Decision Report

Refresh Vacluse and Diamond Bay Project

December 2020

Figure 1 - Servicing catchments of the existing ocean outfalls at Vaucluse and Diamond Bay

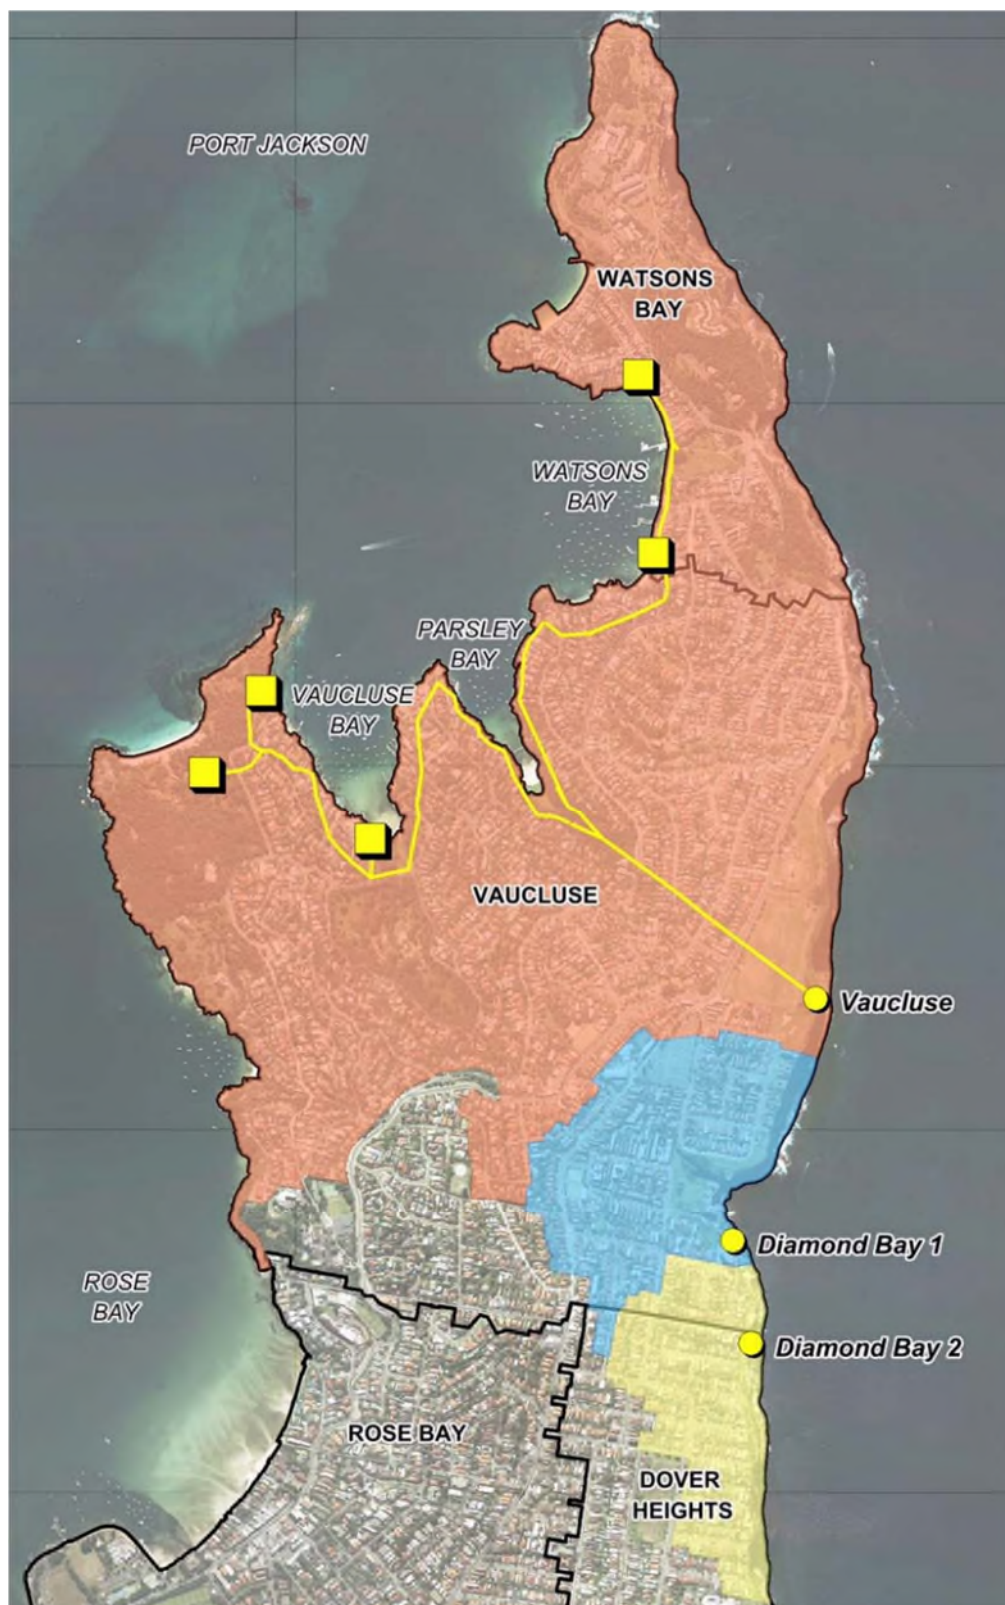
Question regarding the current location of discharge of wastewater in Vacluse and Diamond Bay, and what catchments the outfalls are servicing. Also concern regarding potential discharge into Parsley Bay and why this area was chosen for the location of the wastewater pump station.

The REF does not show the catchment in which are currently serviced by the outfalls that will be redirected.

There are currently three ocean outfalls located in Vacluse, Diamond Bay and Dover Heights that discharge untreated wastewater at the cliff face. Figure 1 shows the location and current catchments serviced by each of the three outfalls. It is worth noting that sections of Rose Bay and Dover Heights (non-coloured area in Figure 1) are already connected to the Bondi WWTP.

In order to collect the wastewater from the Vacluse catchment, the existing large wastewater infrastructure shown in yellow in Figure 1 needs to be intercepted. The existing network has five pumping stations and gravity pipes which transfer flows to Parsley Bay. The Vacluse Ocean Outfall Sewer (VOOS) starts from Parsley and terminates at the cliff face of the Christenson Park. The infrastructure converges near Parsley Bay before it flows via the ocean outfall pipe. As such, Parsley Bay is the ideal location to divert the flow away from the ocean outfall as it requires minimal infrastructure and disturbance to the community.

There will be no planned discharge of wastewater into Parsley Bay. All wet weather overflows will be diverted to the existing Vacluse outfall via the VOOS as per the current operation.

The yellow boxes in Figure 1 below show the locations of existing wastewater pump stations at Watsons Bay and Vacluse Bay.
